DISTRIBUTION CODE MODIFICATION PROPOSAL FORM

Modification Proposal submitted By: Tony Hearne	DATE OF SUBMISSION OF PROPOSAL: 17.02.2021	Modification Proposal Number: <i>(to be assigned by Review Panel Secretary)</i> #52
---	--	---

MODIFICATION PROPOSAL TITLE:	Adoption of new Topology 1A
-------------------------------------	-----------------------------

DCC11.1.3.1 Generator Topologies

Figure 1

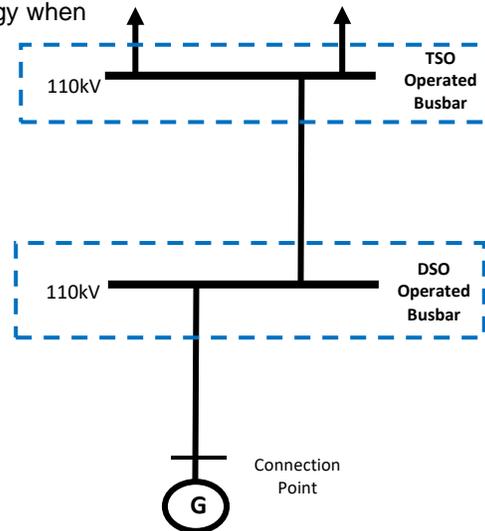
- Augmentation to existing Topology 1 description to distinguish it from the Dublin City network, as described below. New Diagram to replace figure 4.**

PPMs are classed as being connection topology when connected, at 110kV to a **DSO** operated 110kV busbar, which, in turn, is galvanically connected to the TSO operated 110kV system outside of the Dublin City DSO operated 110kV network.

Figure 4A

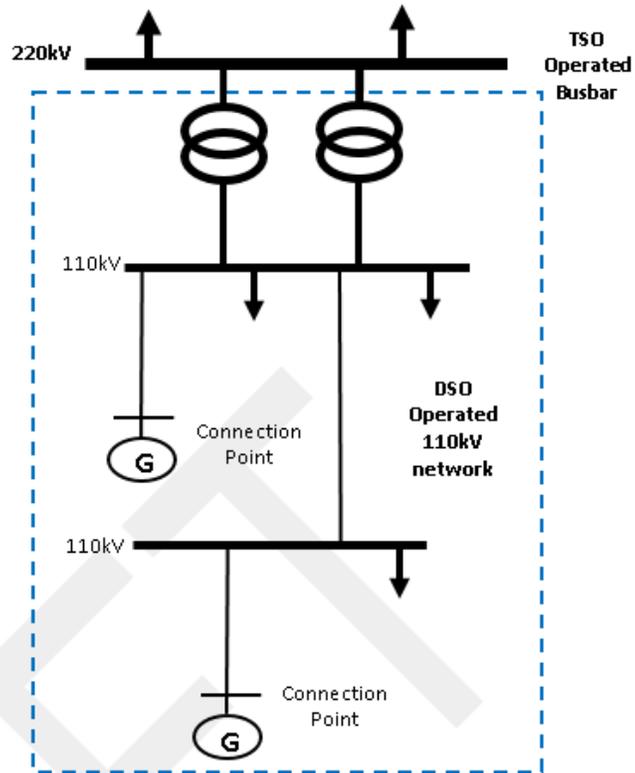
- Creation of a new Generator Topology 1A.**

Generators are now connecting at 110kV, to the Dublin City DSO operated 110kV network. This

topology has very different electrical characteristics to that described by the existing Topology 1 definition. A new description of the topology and a new accompanying diagram, Figure 4A.

PPMs are classed as being connection topology 1A when connected, at 110kV to a **DSO** operated 110kV busbar, which, in turn, is part of the Dublin City DSO operated 110kV network.
